GENERAL APPLICATION

Location Address: 1942 Taylor Street, Hollywood, FL 33020

Explanation of Request: Multi Family Dwelling

SUBJECT: Preliminary Site Plan review for an 18-unit residential development
Owner/Applicant: MEC INVESTMENTS INC
Address/Location: 1942 Taylor St
Net Size of Property: 10,759 sq. ft. (0.25 acres)
Land Use: Regional Activity Center (RAC)
Zoning: North Downtown High Intensity Mixed-Use District (ND-3)
Present Use of Land: Residential
Year Built: 1925 - 1954

COVER SHEET

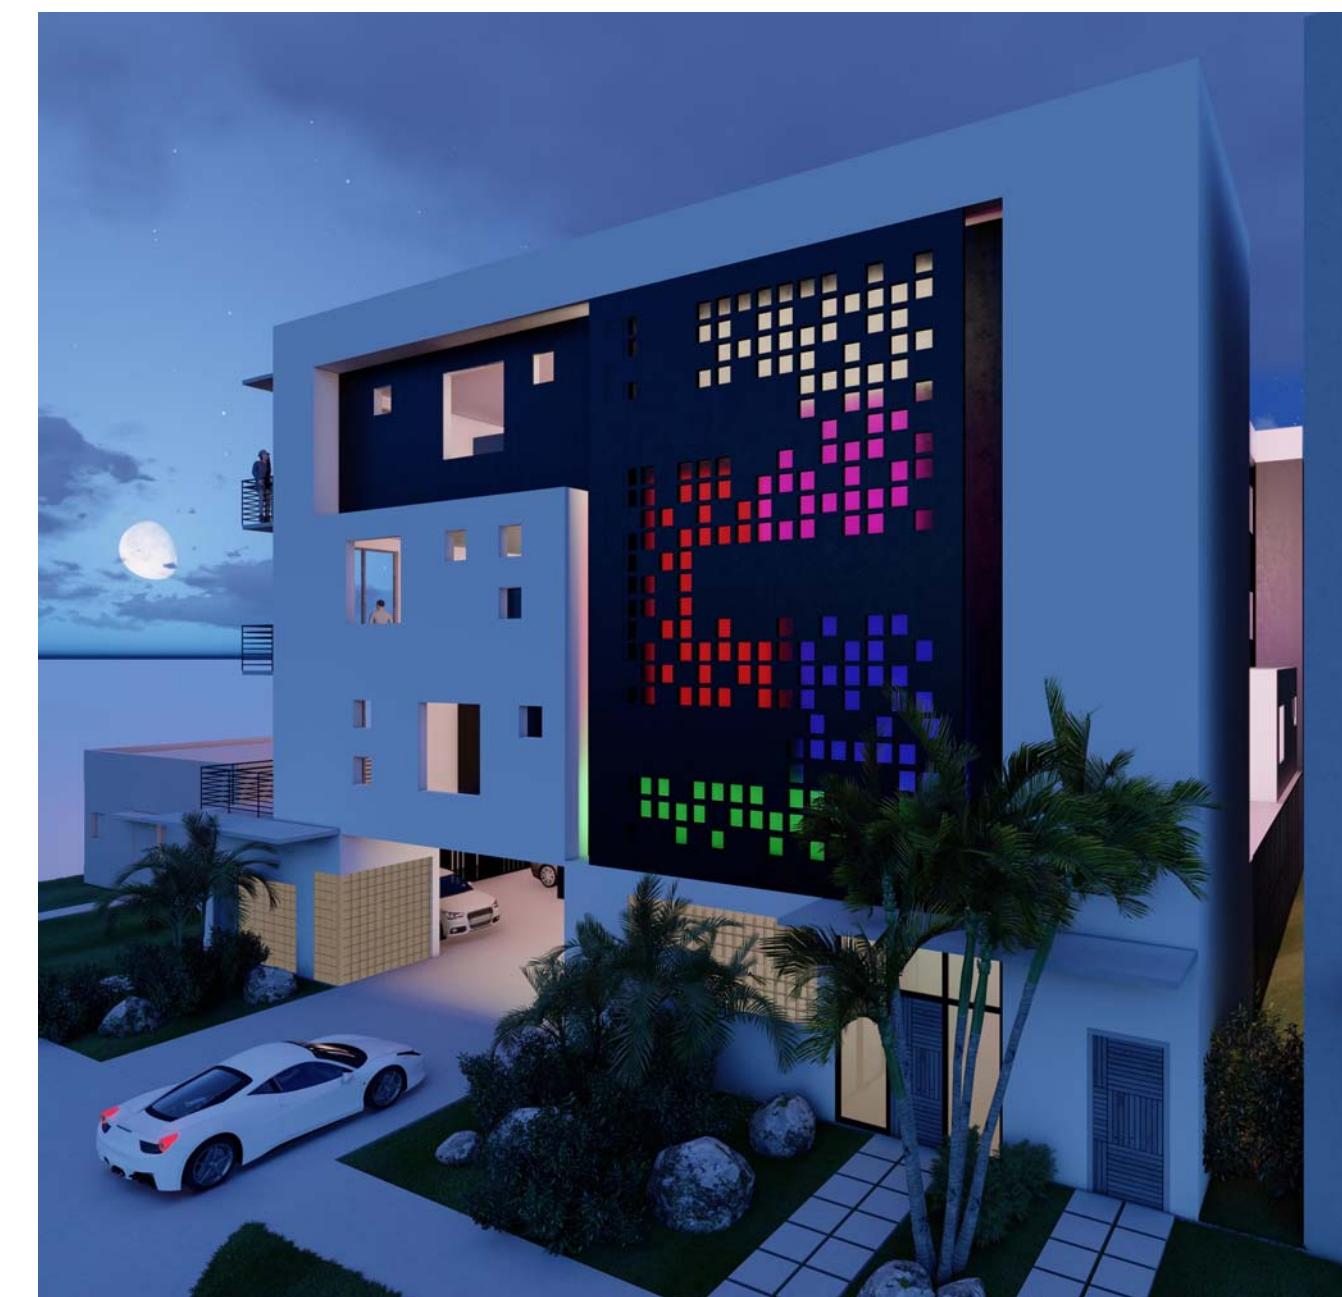
5. Indicate past, current and future meeting dates as they happen (not submittal dates) on Cover Sheet. Indicate specific Board/Committee (i.e. TAC, PDB, etc.) For future Board/Committee dates not known, leave blank until staff has advised of next meeting date. **Refer to A000, dates updated.**

1. Indicate past, current, and future meeting dates as they happen (in addition to submittal dates) on Cover Sheet. Indicate specific Board/Committee (i.e. TAC, PDB, etc.) For future Board/Committee dates not known, leave blank until staff has advised of next meeting date. **Refer to A000, dates updated.**

SITE PLAN

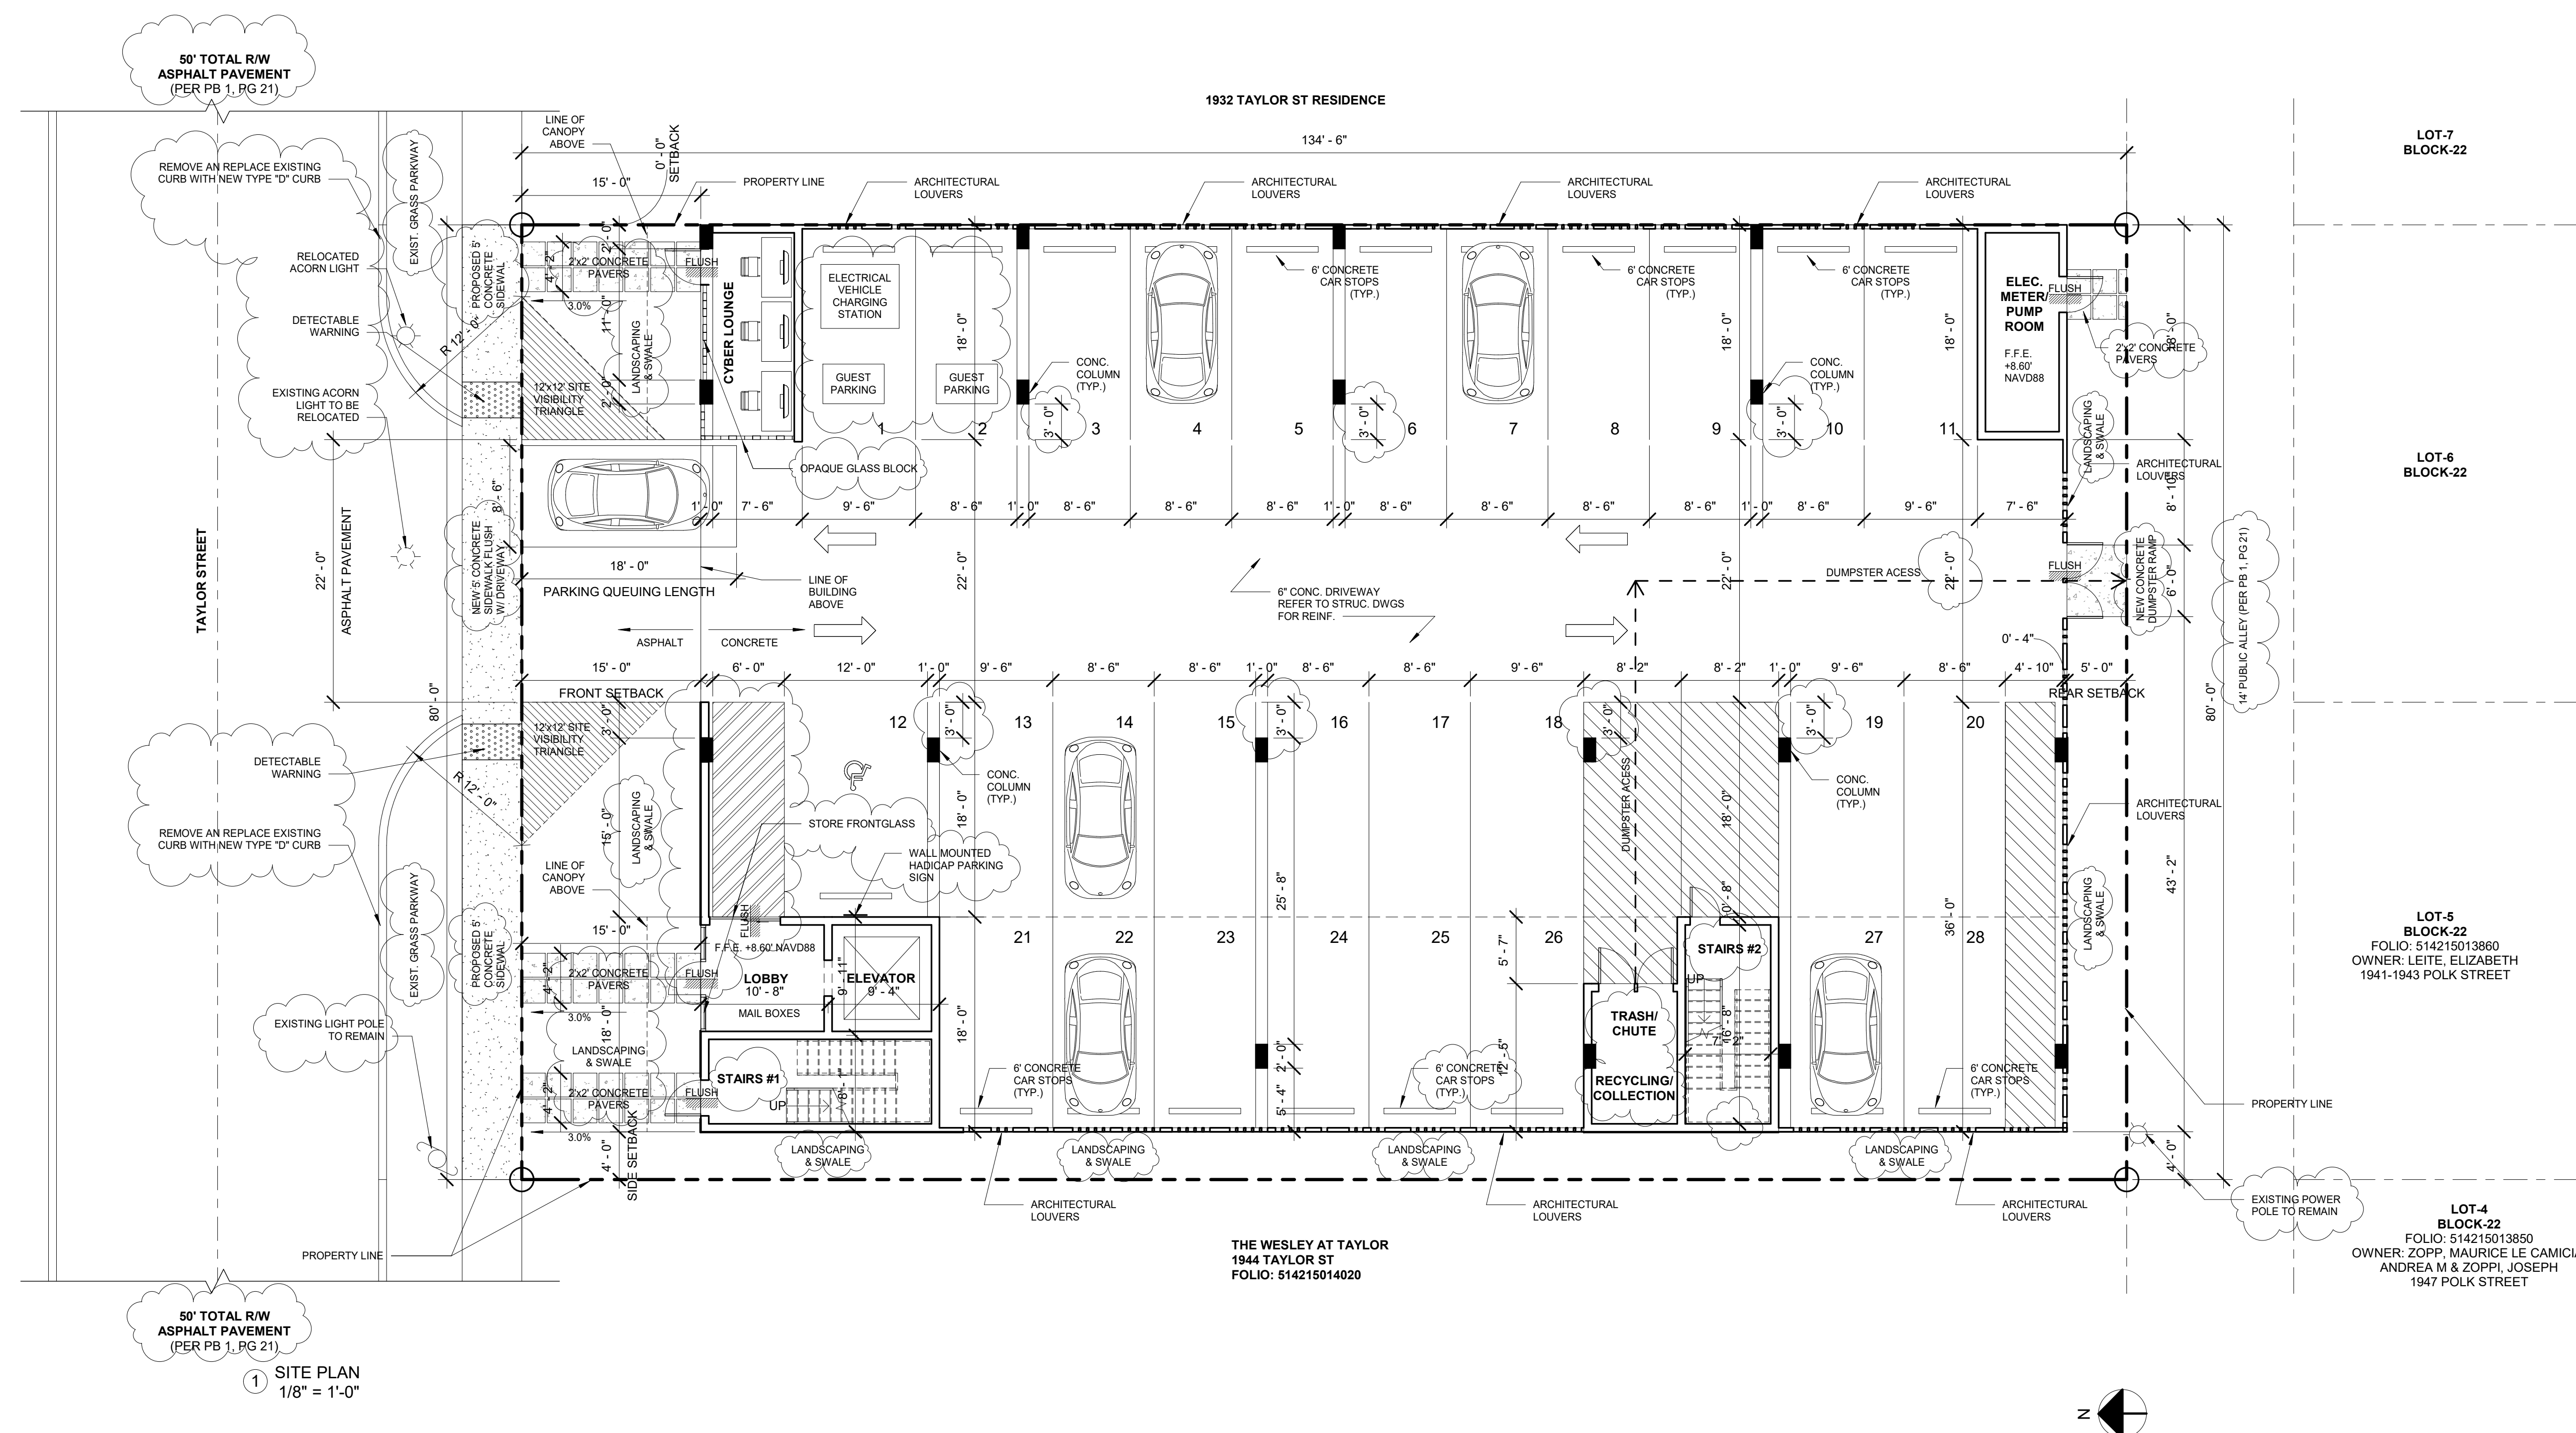
2. Site Plan:
 - a. Include a note on the site plan indicating that all changes to the design will require planning review and may be subject to Board approval. **Refer to A100 notes, note added.**

- d. Indicate columns are at least 3ft from the entrance to a parking space for both sides of parking lot. **Refer to A100, dimensions added.**
 - e. Indicate concrete car stops (6ft long) for parking spaces on the site plan. **Refer to A100, car stops added.**

- i. Indicate on-site plan and renderings a minimum of 40% ground level active use. **Refer to A100 notes, 36' of active use provided (45%).**
 - j. Proving the minimum queuing length of 18 ft at the entrance of the parking garage. **Refer to A100 notes, no garage entry door shall be used to allow for queuing.**

- a. Dimension and label all features of the existing right-of-way and show limits of the rights-of-way on both sides of Taylor Street. **Refer to A100.**

- b. Include and show all surrounding elements as applicable, i.e. adjacent alley, road, properties, limits of rights-of-way on both sides of adjacent streets or alleys including any curb cuts, edge of pavement, swale, sidewalks etc. **Refer to A100.**

- c. Provide dimension for column setback from drive aisle on the east side of the parking area, minimum 3’ is required. **Refer to A100.**
 - d. Please provide dimensions to show the electric meter/pump room will not encroach into the required drive aisle. Reduce this size of this room. Provide clear space dimension in drive aisle (minimum 22 feet.) **Refer to A100, 22’ achieved.**

- e. Indicate and label property line on all sides of the site. **Refer to A100.**
 - f. Demonstrate that perimeter wall footing/wall does not encroach into adjacent property or ROW. i.e. provide wall cross-section or show setback. **Refer to A200, Section 2/A200 added.**

- g. Provide dimensions for all setbacks, applicant has a door exiting to the west that may require a landing/walkway all walkways are to be setback a minimum of 3 feet from the side property lines. Please ensure this requirement is met. **Refer to A100, door removed.**

- h. Identify all material types proposed (i.e. apron, parking lot, sidewalk, and walkways, etc.) **Refer to A100, all materials called out.**
 - i. Please number and label each stairwell on site plan. **Refer to A100, stairs numbered.**

- 6) Sheet A-100, the vehicle queueing space entering the garage is in conflict with parking Stall 1, vehicle queueing space shall not overlap into the parking backout space. Refer to A100 , previous parking stall 1 replaced with cyber lounge.

- 8) Please dimension the length and width of all proposed walkways and ramps. (i.e., front concrete walkway.) Refer to A100, dimensions added.
- 9) Parking stalls 1, 21 and 29 shall be 9.5' width as there is obstruction on one side. Refer to A100, current parking stall 1, 11, 21, 26 & 27 are 9.5' (29 has been removed).

- 13) All non-vehicular areas shall be stripped and clearly identified. This stripping shall not be the same stripping as the ADA accessible aisle. Please show on plan. (i.e. next to Stalls 21/29 and trash area.). Refer to A100, ADA stripping pattern changed.

EAST ELEVATION RENDERING

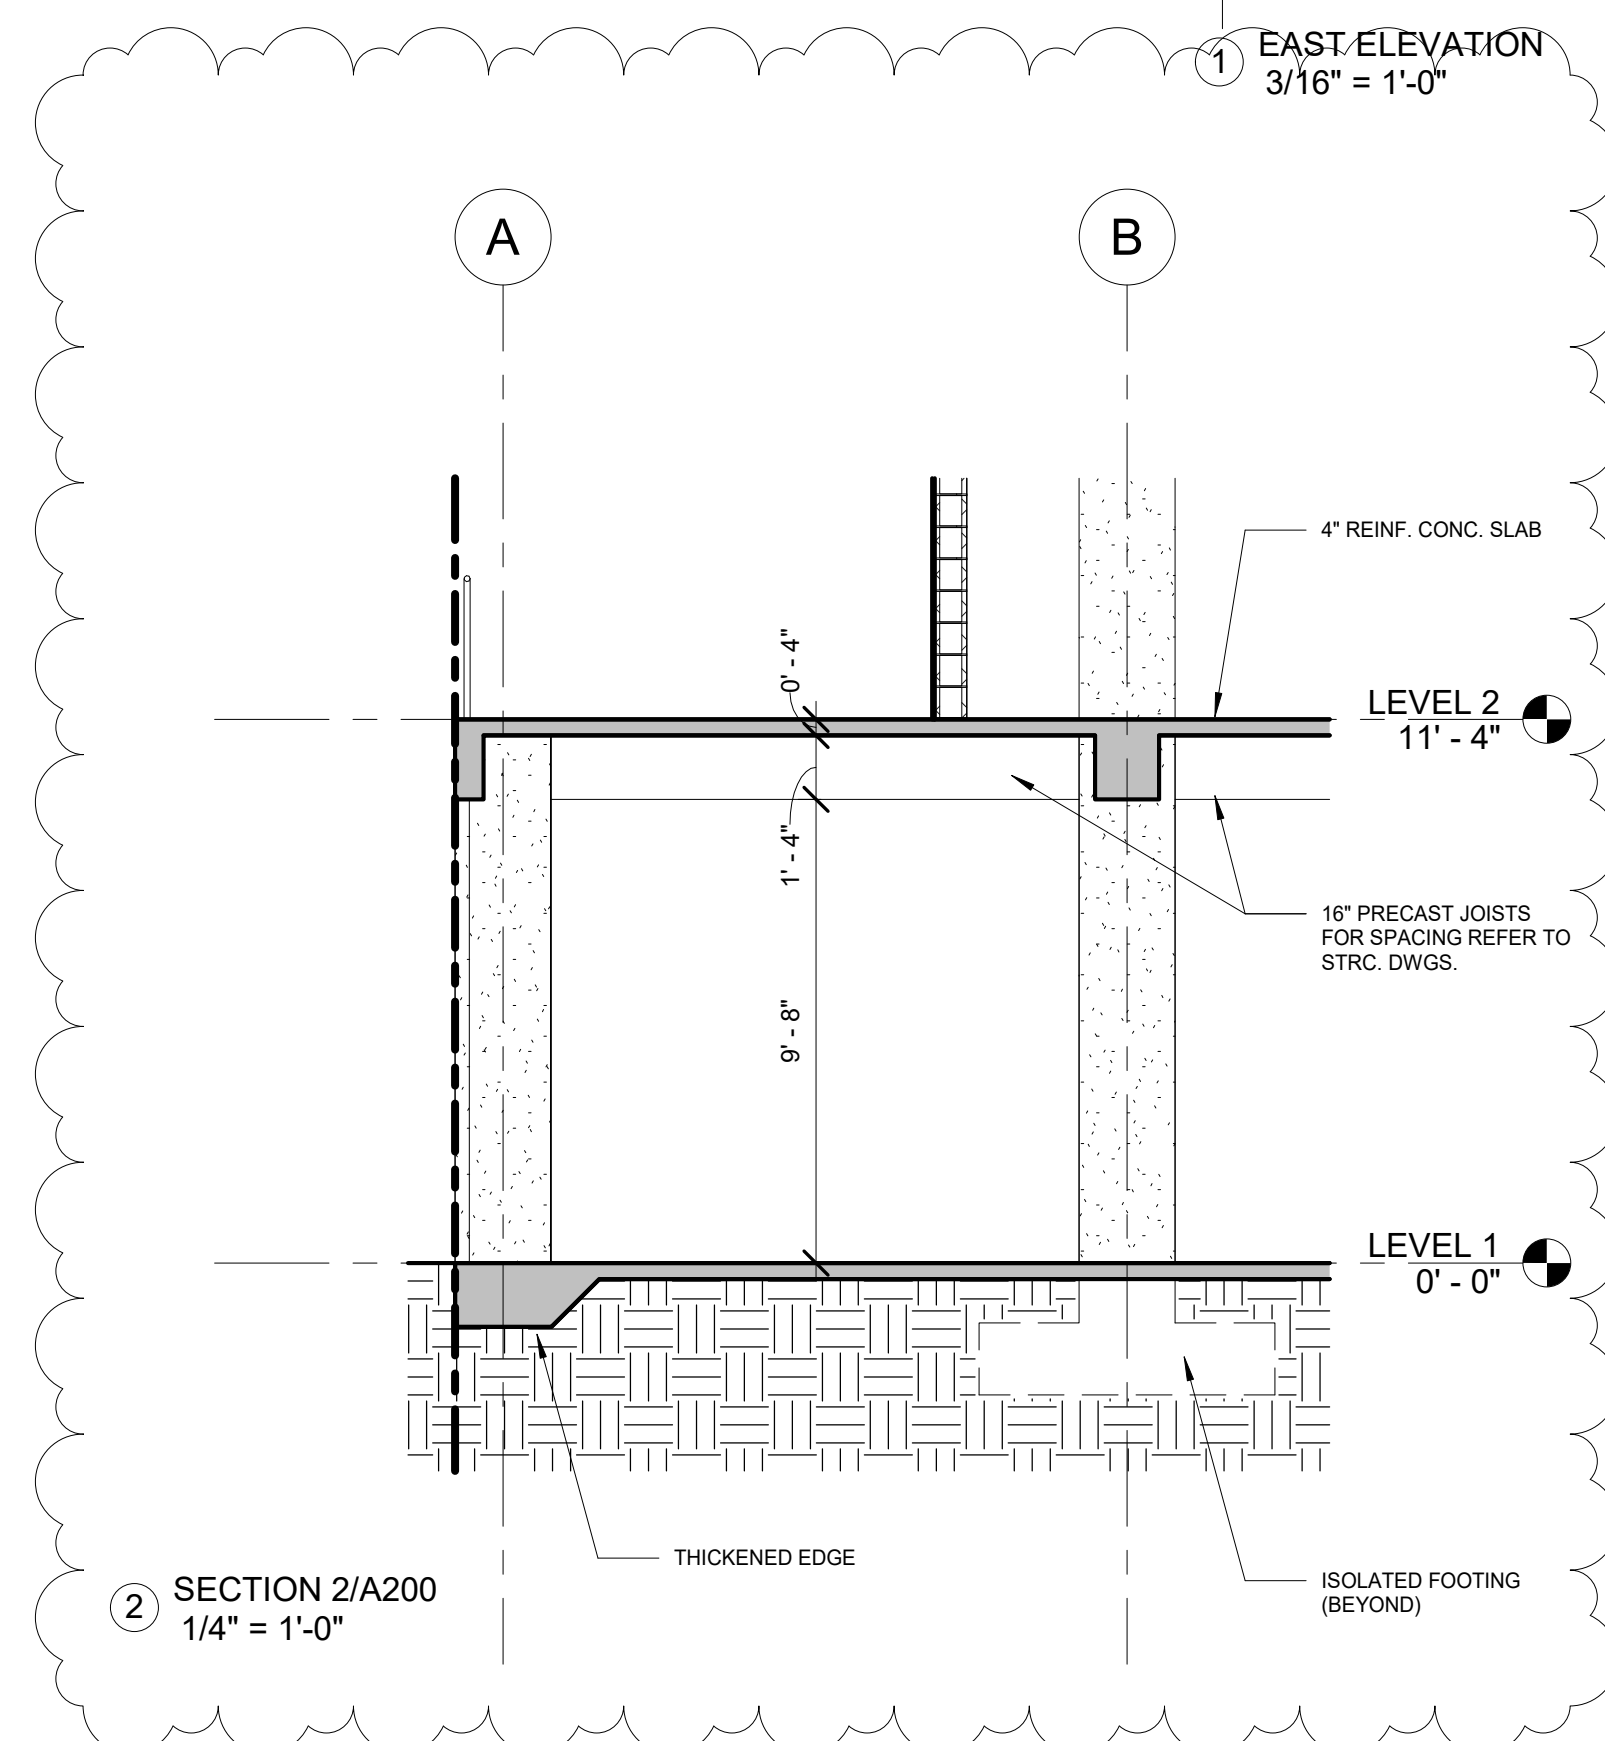
- 1. Provide a rendering of all the sides. **Refer to A000, A200a, A201a, A202a, A203a & A205.**
- 2. Provide a note: All changes to the design will require Planning review and may be subject to Board approval. **Refer to A100 notes, note added.**
- 3. Indicate and demonstrate access to the dumpster on site plan. Label dumpster pad/ramp that provides access. **Refer to A100, path lines added.**
- 4. Work with the Building Department to ensure that adequate ventilation is provided for the parking garage. **Refer to A100 notes, note added.**

3. The proposed architecture of the building appears to be flat with almost no articulation. The CRA would like to recommend adjusting the massing of the building and/or incorporating additional architectural elements to help improve the architecture of all four elevations. **Facades modified, refer to A000, A200a, A201a, A202a, A203a & A205.**
